Item ID: D212-664-101TRN

Item Name: Crosstube Turning Detail

DART AEROSPACE LTD		Work Order:	101162
Description: Crosstube Assembly (205/212/412 High Fwd)		Part Number:	D212-664-141
Inspection Dwg: D212-664-141 Rev: D		Page 1 of 2

DRAWING NO. D212-664-141	TITLE XTUBE ASSY (205/212/412 HI FWD)	REV. D	DART AEROSPACE LTD ENGINEERING ORDER		D.E.O. NO. D212-664-141-D-1	SHEET NO. SHEET 1 OF 2	SCALE NTS
DRAWN	CHECKED	MP	MFG. APPR.	EE	APPROVED	MP	DE APPR.
DATE 11.04.07	DATE 11.04.11		DATE 11.04.12		DATE 11/04/12		DATE 11.04.12

D212-664-501
BENT TUBE

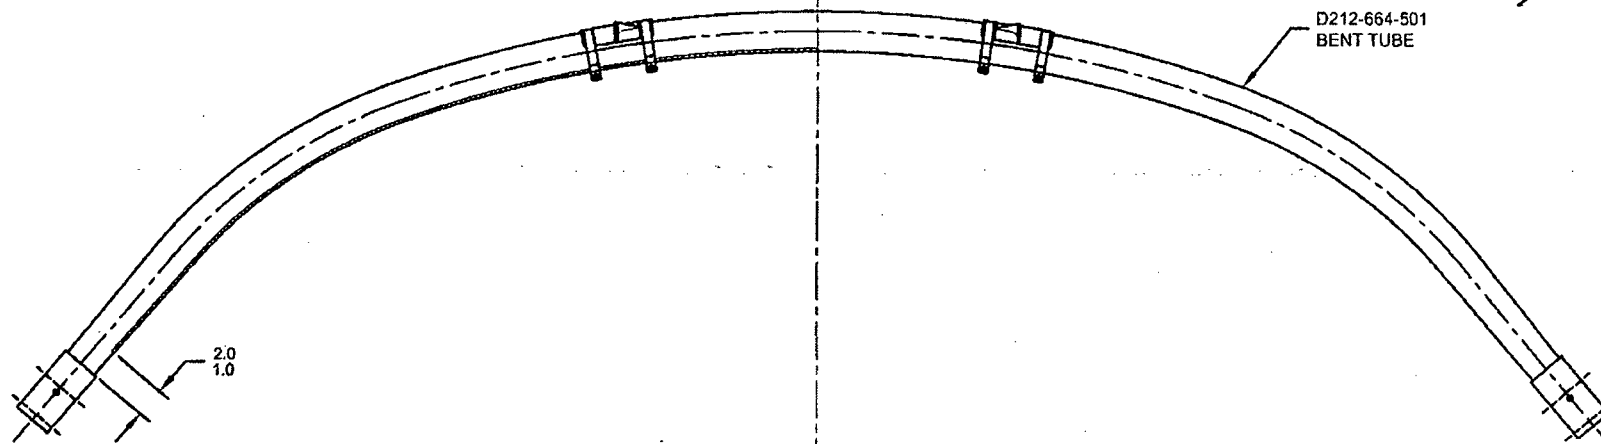
ADD AN INSPECTION WINDOW TO UNDERSIDE OF CROSSTUBE.

NOTES 2 OF SHEET 1 IS AMENDED AS FOLLOWS:

MASK AREA PRIOR TO PAINTING,
REMOVE MASKING AFTER PAINT
AND APPLY CLEAR COAT

- 2) FINISH: CHEMICAL CONVERSION COAT PER DART QSI 005 4.1
PRIME INSIDE AND OUTSIDE PER DART QSI 005 4.2
MASK UNDERSIDE OF CROSSTUBE AS SHOWN (HATCHED AREA) AND
PAINT OUTSIDE PER DART QSI 005 4.2
REMOVE MASKING AND APPLY CLEAR COAT
